Historic Zoning Commission

December 19, 2024

Rules of Procedure

Agenda

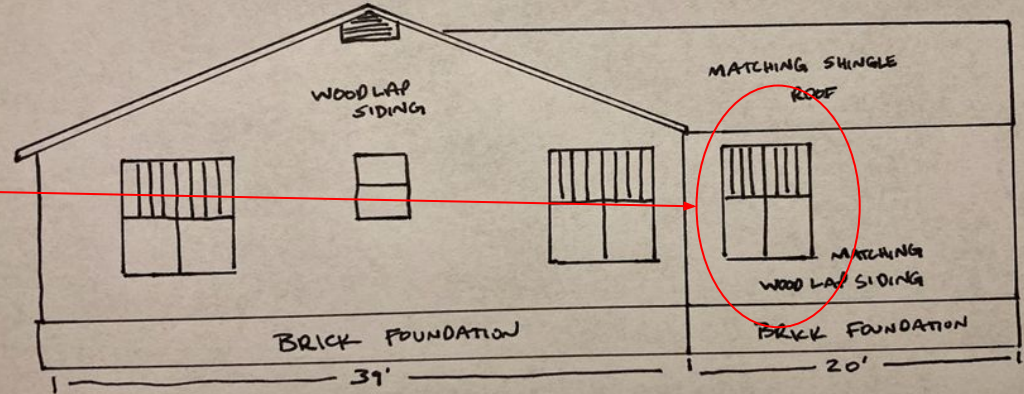
Applicant to
confirm if this
is a proposed
new window

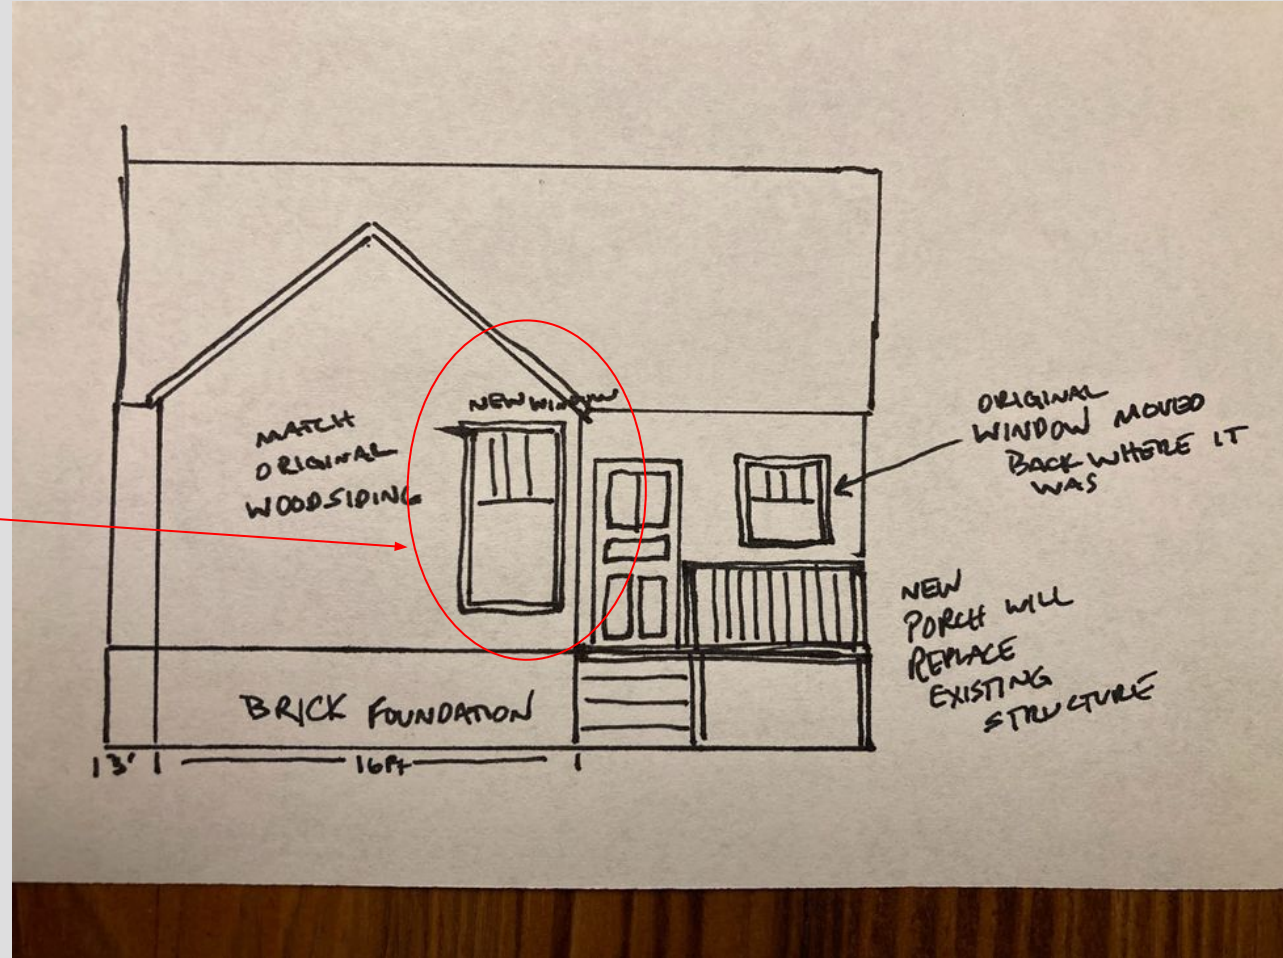
Applicant to confirm if this is a new window or proposing to reuse existing window on rear facade.
